CITY OF PORTLAND

has permission to Summer cottage 3 bedrooms /12 Bath

AT 29 Spring Cove Ln

Permit No:	05-0947	Issue Date:	AUG 31 2005	PERMIT ISSUED
				083E A051001

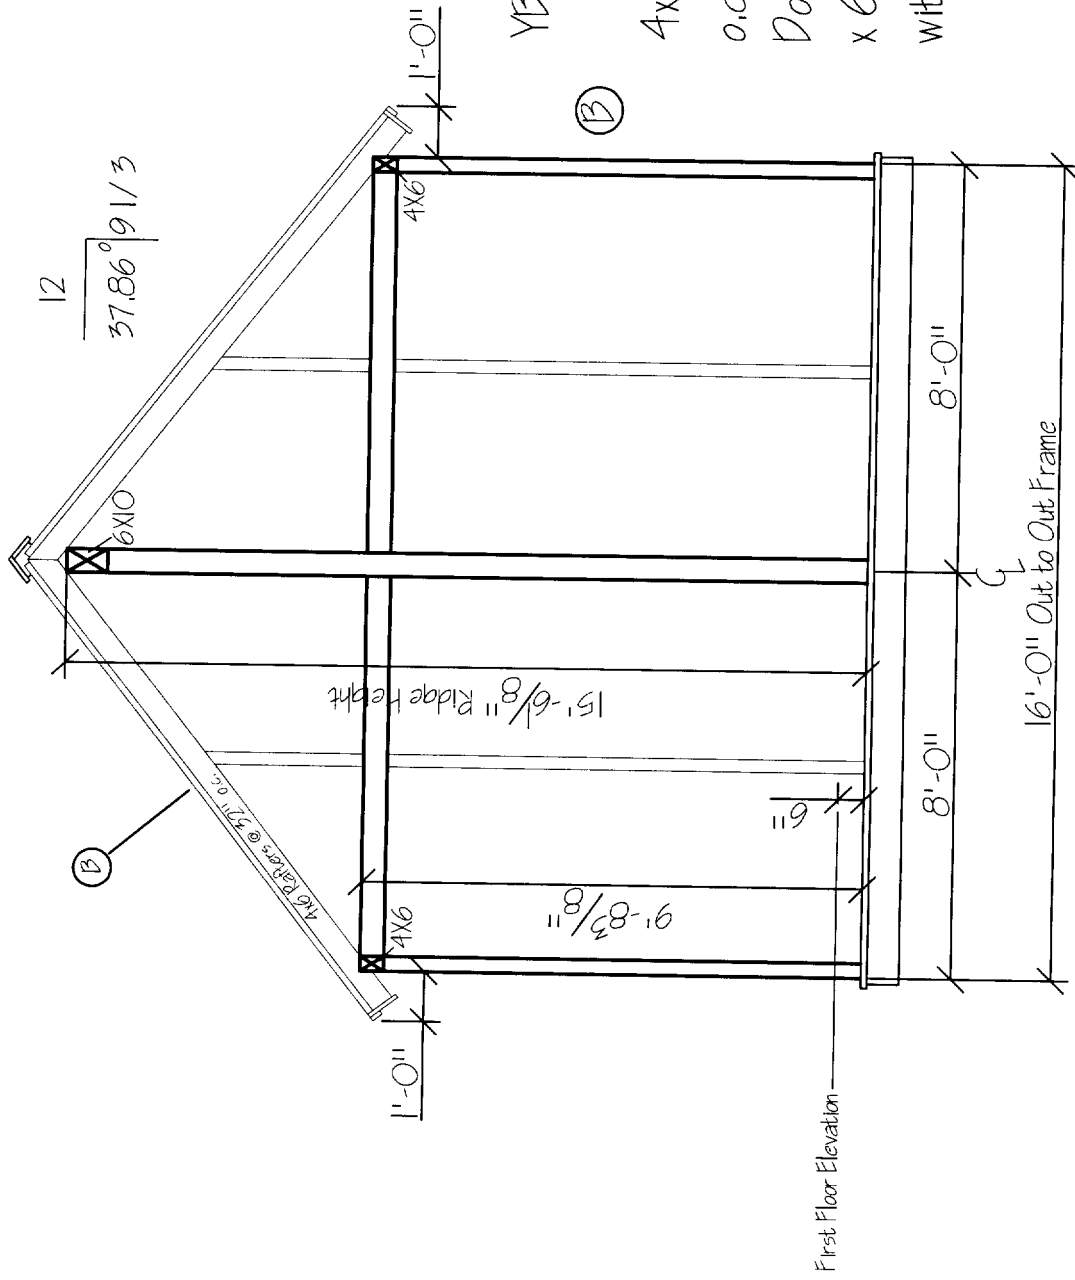
ONE AND TWO FAMILY	PLAN REVIEW	CHECKLIST
Soil type/Presumptive Load Value (Table R401.4.1)		
Component	Submitted Plan	Findings/Revisions/Dates
STRUCTURAL		
(✓) Footing Dimensions/Depth (Table R403.1 & R403.1(1), (Section R403.1 & R403.1.4.1)	Not shown	OK 8" wall 16" x 8" footing
Foundation Drainage, Fabric, Damp proofing (Section R405 & R406)	OK	
Ventilation/Access (Section R408.1 & R408.3) Crawls Space ONLY	N/A	
(Ⓢ) Anchor Bolts/Straps, spacing (Section R403.1.6)	1/2" - 6' OC 1/2" - 6' OC	
Lally Column Type (Section R407)		
Girder & Header Spans (Table R 502.5(2))		
Built-Up Wood Center Girder Dimension/Type	Shows - 3-2x12's - LVL'S? or wood?

(a) Sill/Band Joist Type & Dimensions	2x8 PT SILL	
First Floor Joist Species Dimensions and Spacing (Table R502.3.1(1) & Table R502.3.1(2))	2x8 Blocking under posts - NOT solid bearing	OK bearing on LVL'S
Second Floor Joist Species Dimensions and Spacing (Table R502.3.1(1) & Table R502.3.1(2))	2x8'S	
Attic or additional Floor Joist Species Dimensions and Spacing (Table R802.4(1) and	N/A

R802.4(2))		
Pitch, Span, Spacing & Dimension (Table R802.5.1(1) - R 802.5.1(8))		
Roof Rafter; Framing & Connections (Section R802.3 & R802.3.1)	Need better labeled details OK 2x6's 16" OC	
Sheathing; Floor, Wall and roof (Table R503.2.1.1(1))	walls - not noted floor - 3/4 T+G walls - 5/8"	
Fastener Schedule (Table R602.3(1) & (2))	not noted	
Private Garage (Section R309) Living Space ? (Above or beside)	N/A	
Fire separation (Section R309.2)	N/A	
Opening Protection (Section R309.1)	N/A	
Emergency Escape and Rescue Openings (Section 910)	noted on first floor plan	
Roof Covering (Chapter 9)		
Safety Glazing (Section R308)	OK - noted on 1st floor plan - Need in Stairwell	
Attic Access (Section R807)	N/A	
Chimney Clearances/Fire Blocking (Chap. 10)	0" clearance	
Header Schedule (Section 502.5(1) & (2))	not shown -	3- 2x8's
Energy Efficiency (N1101.2.1) R-Factors of Walls, Floors, Ceilings, Building Envelope, U-

Factor Fenestration		
7 Type of Heating System	NOT shown	
Means of Egress (Sec R311 & R312)		
Basement 2		
Number of Stairways 3		
Interior 1		
Exterior 2		
8 Treads and Risers (Section R311.5.3)	Inter shows - 10" T 7 3/4" R - no other stairs labeled	
Width (Section R311.5.1)	3-6 - OK	
9 Headroom (Section R311.5.2)	not shown	
10 Guardrails and Handrails (Section R312 & R311.5.6 - R311.5.6.3)	not shown — need handrail on stairs	
11 Smoke Detectors (Section R313)		
Location and type/Interconnected	not shown	
Dwelling Unit Separation (Section R317) and IBC - 2003 (Section 1207)	N/A	
12 Deck Construction (Section R502.2.1)	not shown - OK

(13) No outdoor shower

SITE PLAN

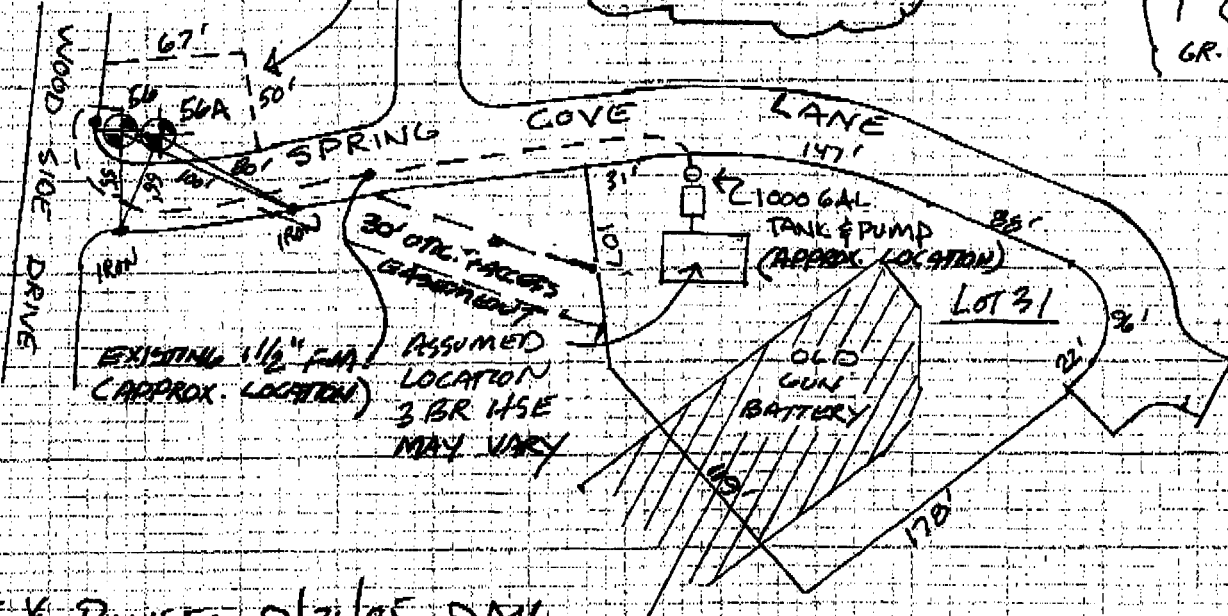
**** NOTE: SEPTIC TANK AND PUMP TANK TO BE LOCATED A MIN. OF 8' FROM FOUNDATION AND 10' FROM PROPERTY LINE. 9/21/05 DAK**
